CITY OF ALBUQUERQUE

RE: **Lot 20 Block 5 Volcano Cliffs Unit 19 SAD 228**
7831 Urraca St. NW
Grading and Drainage Plan
Engineers Stamp Date 4/17/2021 (D10D003H20)
Pad Certification Date 6/3/2022

Based upon the information provided in your submittal received 6/6/2022, this plan is approved for Building Permit.

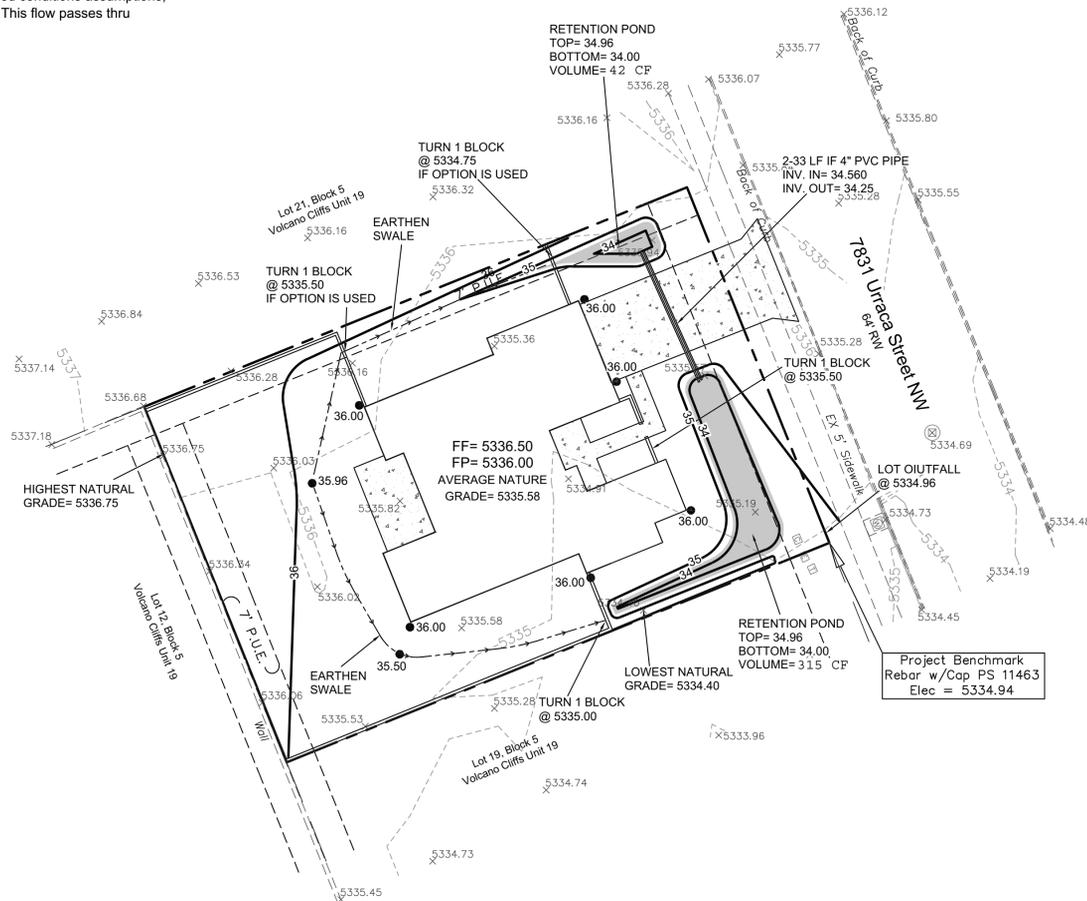
Reiterate to the Owner/Contractor that a separate permit for a garden/retaining wall must be obtained, with the approved G&D plan and Pad Certification. Also, let the owner/contractor know that if a pool is to be added in the future the G&D plan will need to be modified showing the location of the pool and the land treatment differences. Also advise the owner & Contractor that dirt is not allowed in the public right of way to climb the curb. Crusher fines or lumber is allowed. If dirt is used this will delay going forward with the construction of the home.

Prior to Certificate of Occupancy release, Engineer Certification per the DPM checklist of this plan will be required.
